STATE	PROJECT	SHEET NUMBER
CA	CA FLAP NEV 40(1) DONNER PASS	C11

AMENDMENT A009
7/27/21 Revised Profile per RFI 021

STATE	PROJECT	SHEET NUMBER
CA	CA FLAP NEV 40(1) DONNER PASS	C14

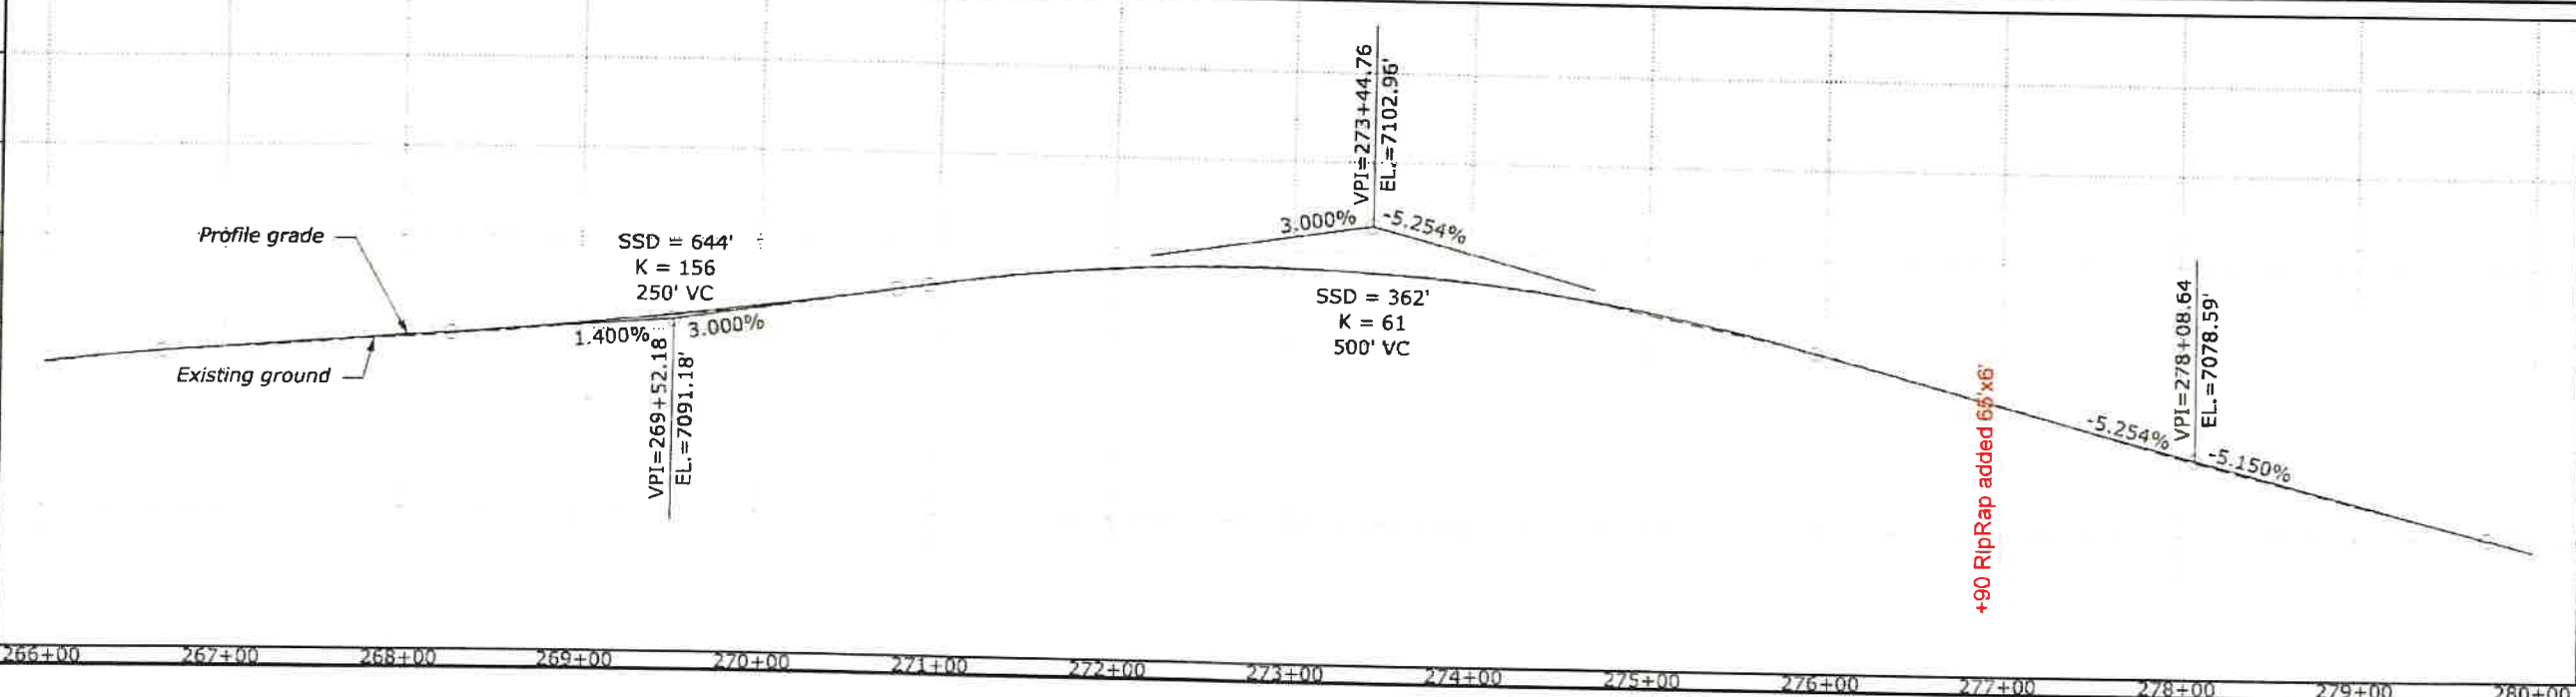
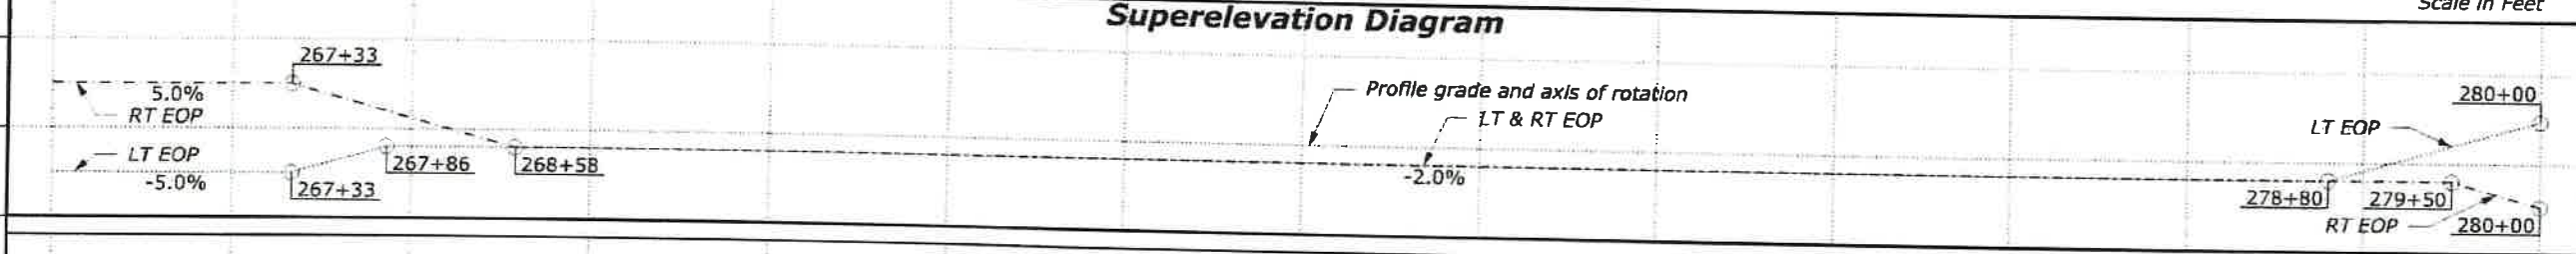
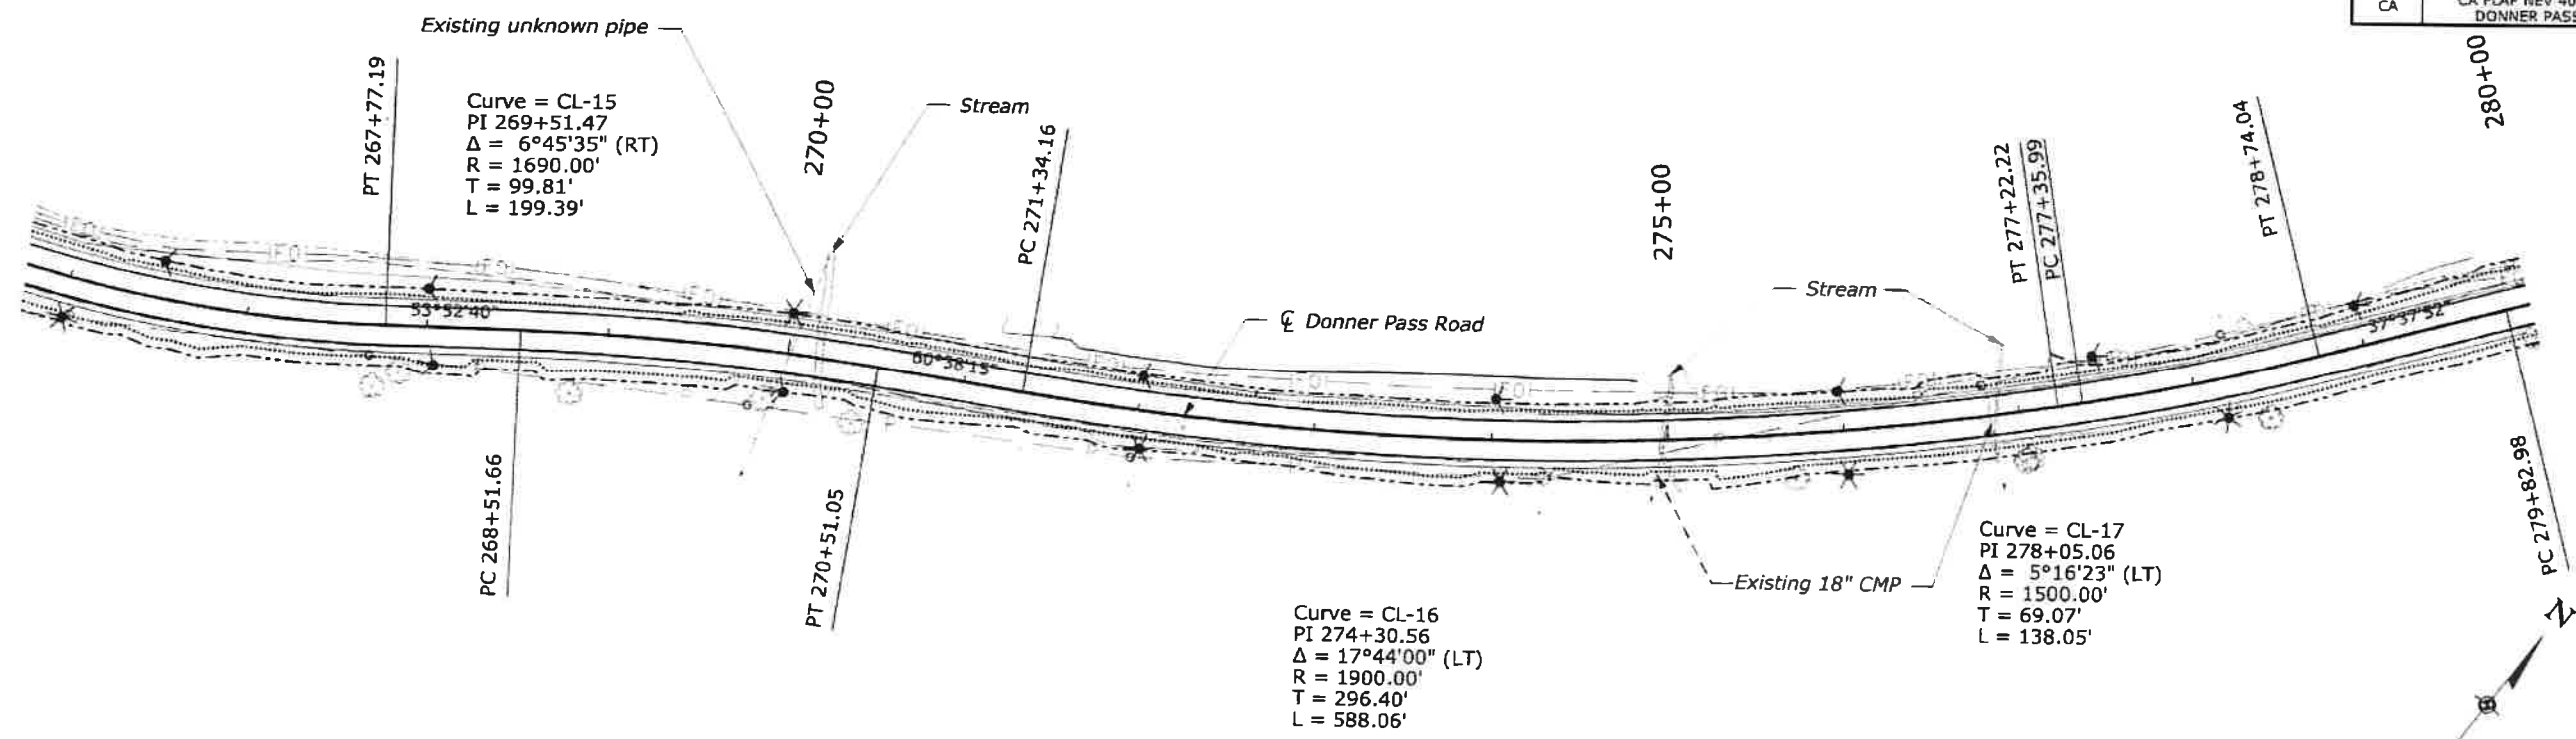
+90 RipRap added 6'x6'

**DONNER SKI RANCH
 STORM SYSTEM STA 293+31**
 Sheet 1 of 1

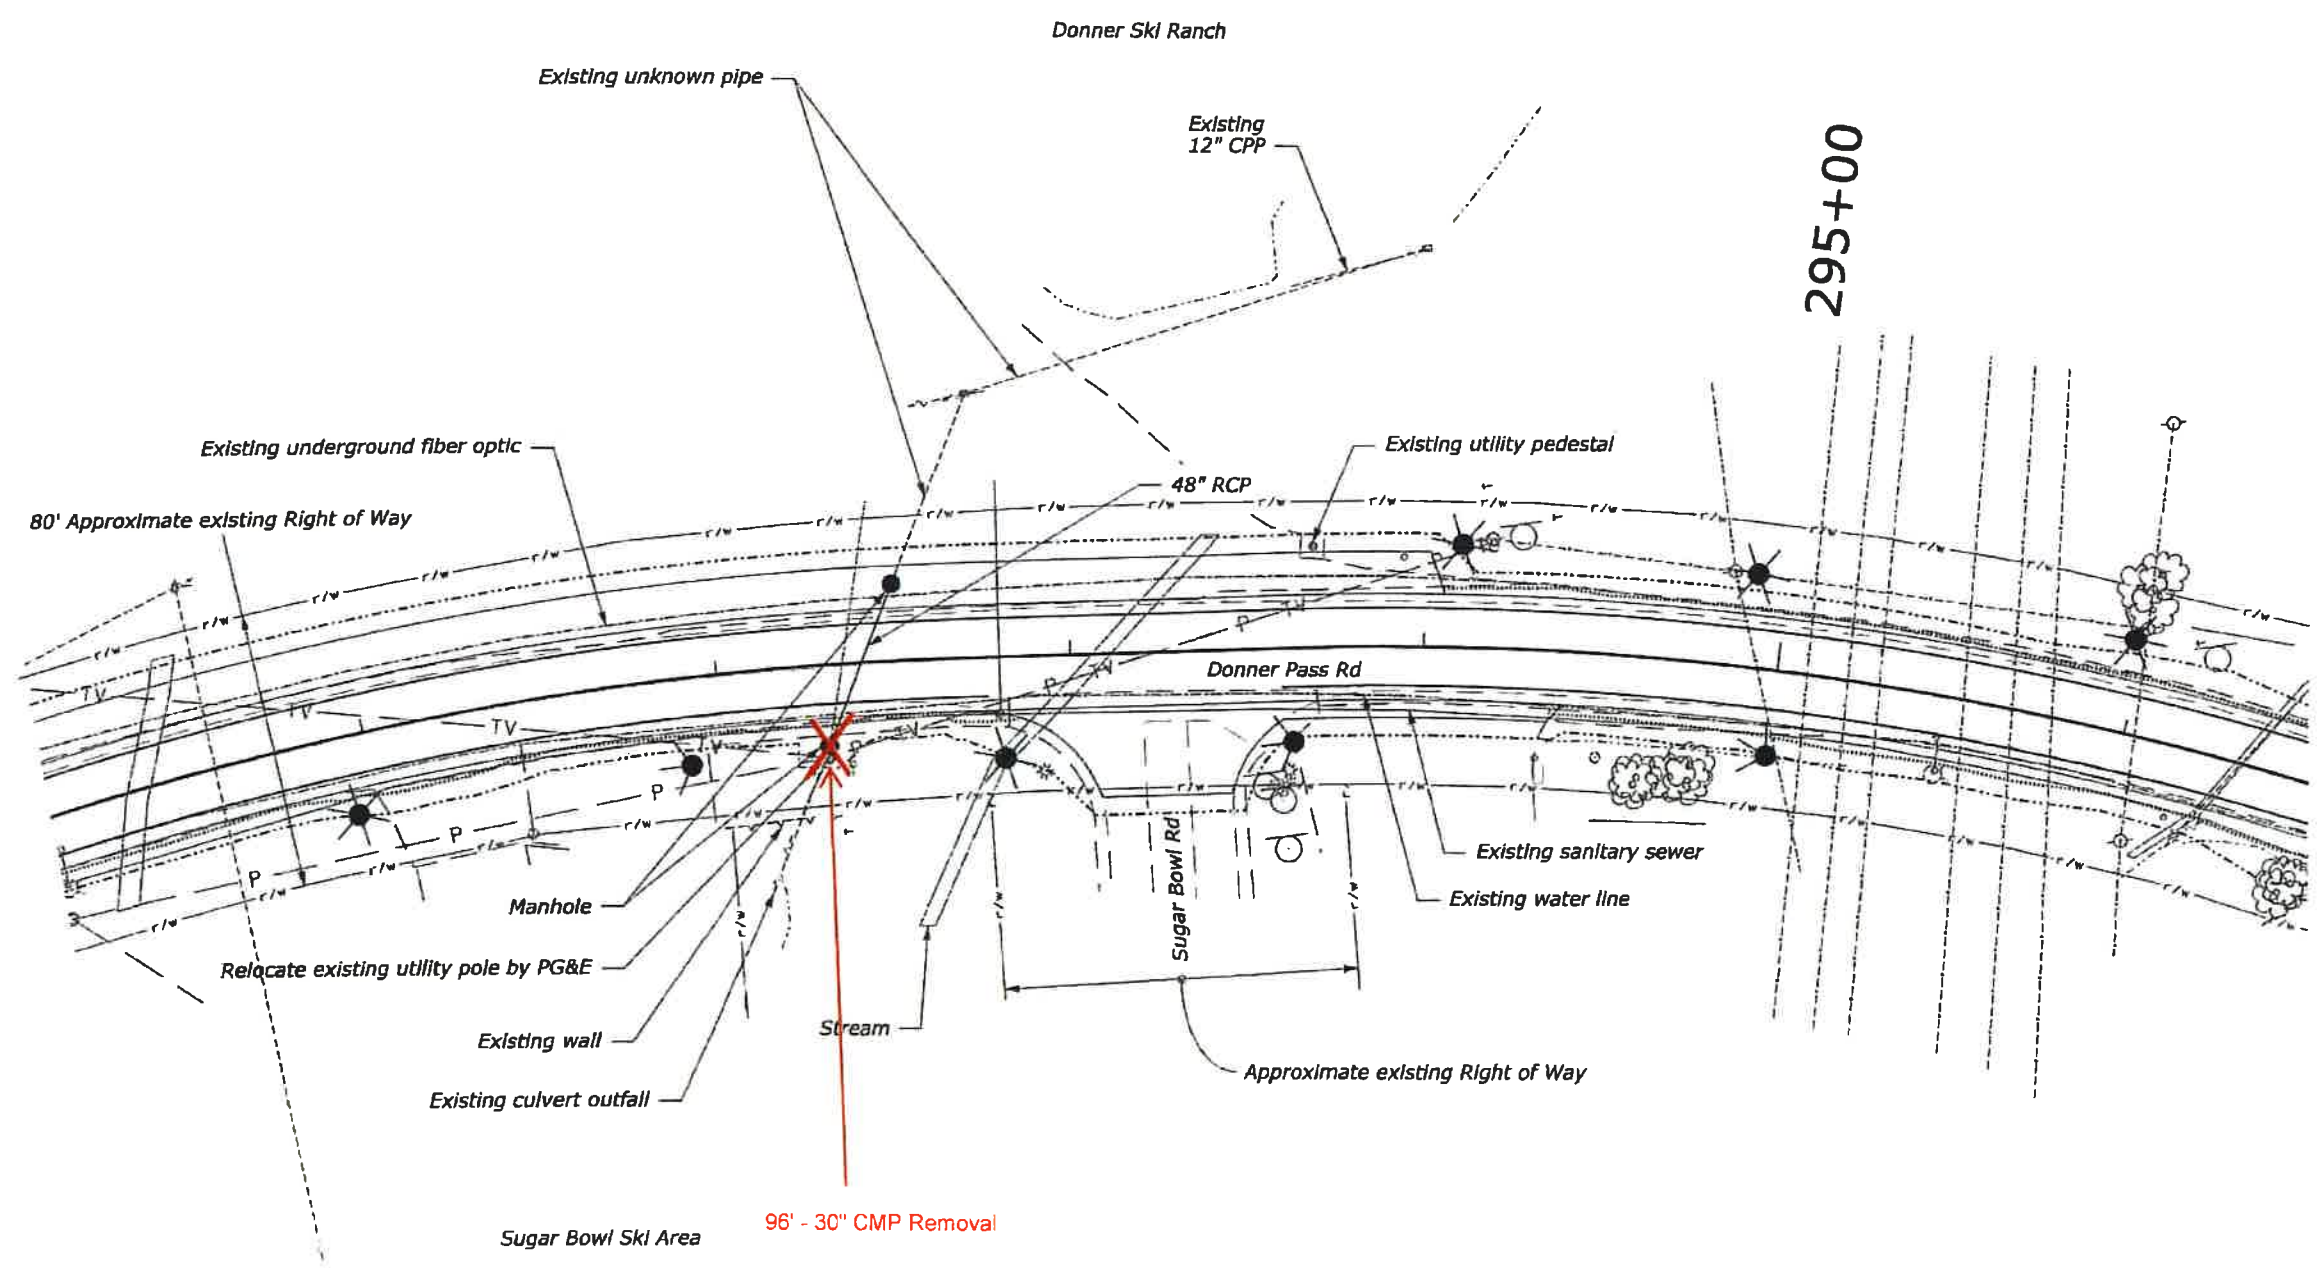
- 96' - 30" CMP Removal
- 48" - 48" RCP Install
- Eliminate Manhole RT
- Remove 2 Headwalls

ROCKERY DETAIL
STATION ~~261+22~~ TO 262+36
261+68

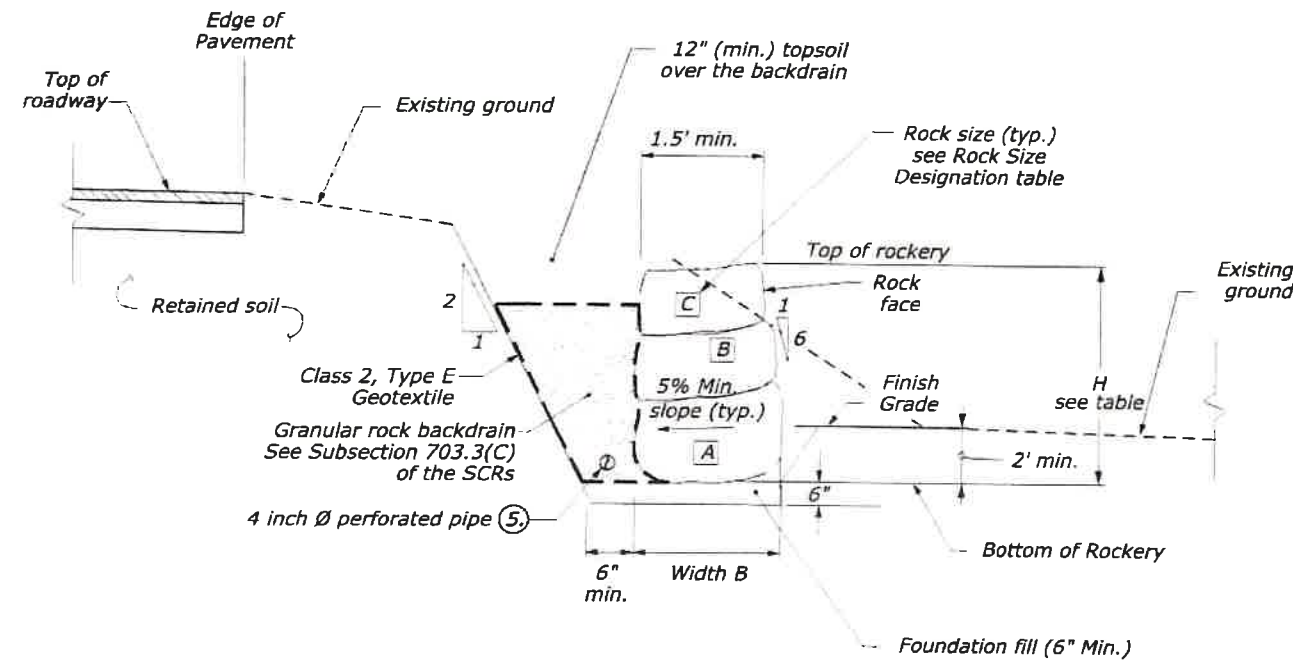
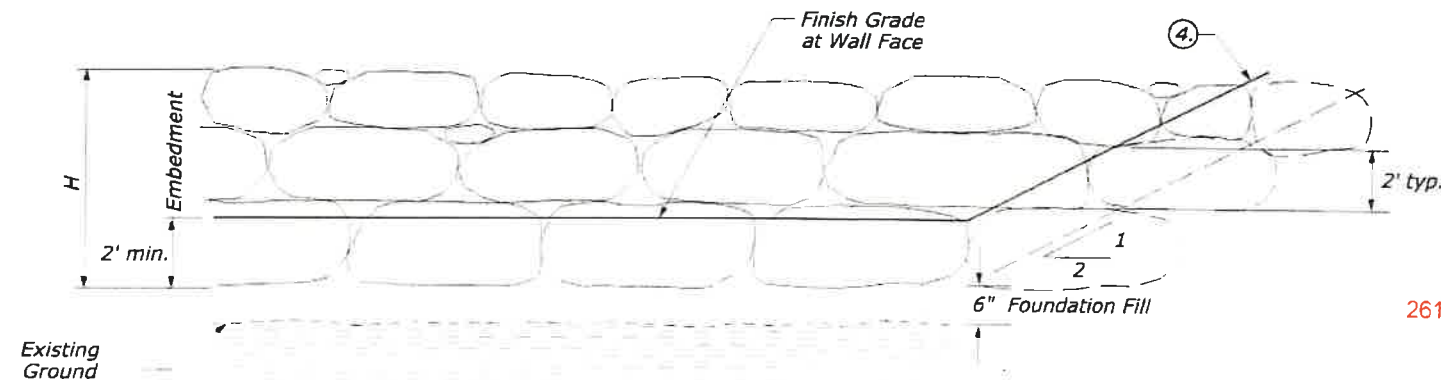
Station ~~261+22~~ to 262+36
261+68

**STATION 324+70 to 324+90
ROCK CUT PLAN**

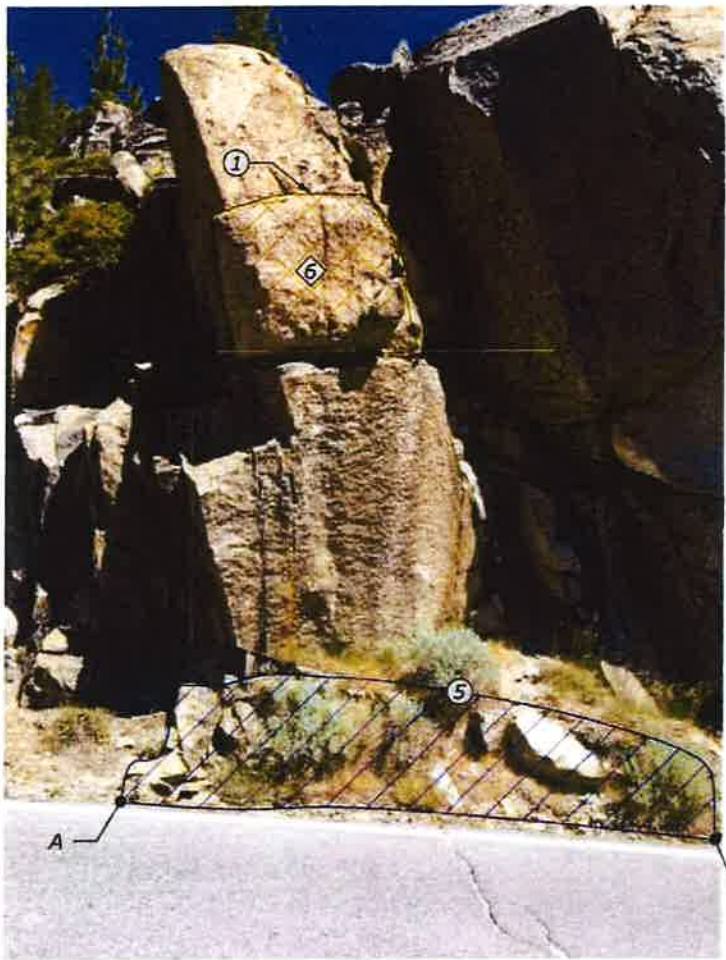
Rock Dowels installed at 324+60 LT - 10LNFT & 12LNFT
